PRE-APPLICATION MEETING NOTES

DATE OF PRE-APPLICATION MEETING: 09/29/21, PRE21-0026

SUBJECT PROPERTY ADDRESS: 2400 Douglas Avenue (Newberg High School CET)

Demolition of CET Buildings and construction of new two-story CET building.

SITE PLAN

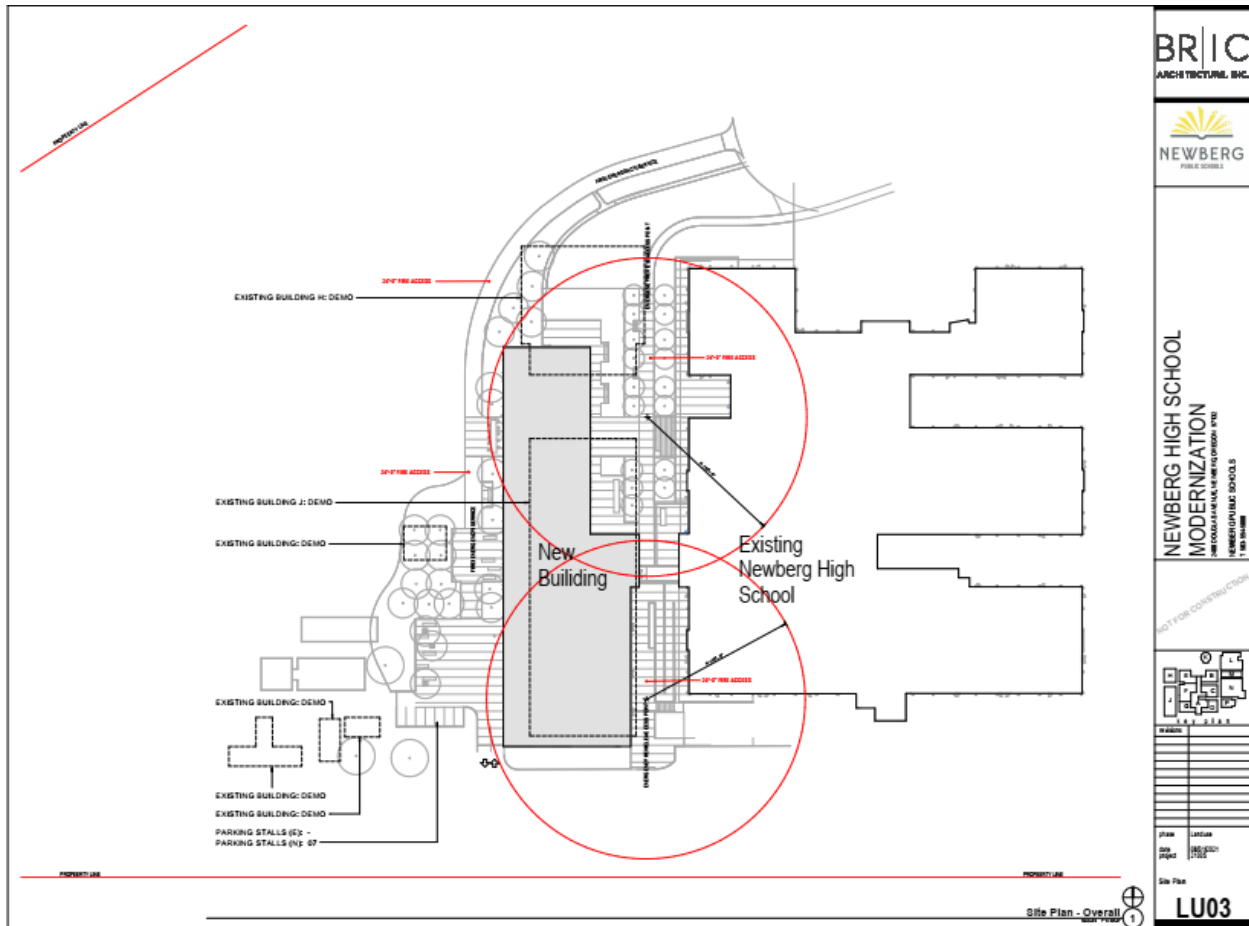
- Fire flow analysis required.
- Hydrant no further than 600 feet from school (new CET building).
 - Contact Ty Darby: Ty.Darby@tvfr.com
- Fire Lane access on north and west sides, would like 20 feet wide and paved but can be gravel and maintained.

Based on the pre-application discussion the project boundary does would not be adjacent to any public streets and therefore it's anticipated that frontage improvements would not be required. This assumption is to be confirmed with the land-use submittal.

Stormwater: There is a 15-inch stormwater line in N Deborah Road and there will eventually be a stormwater line in N Elliot Road as part of the Elliot Road Project. The base bid is listed as 14,230sqft and the alternate is 18,925sqft. Based on the applicant's proposal they will need to address stormwater created from the new impervious surfaces being proposed.
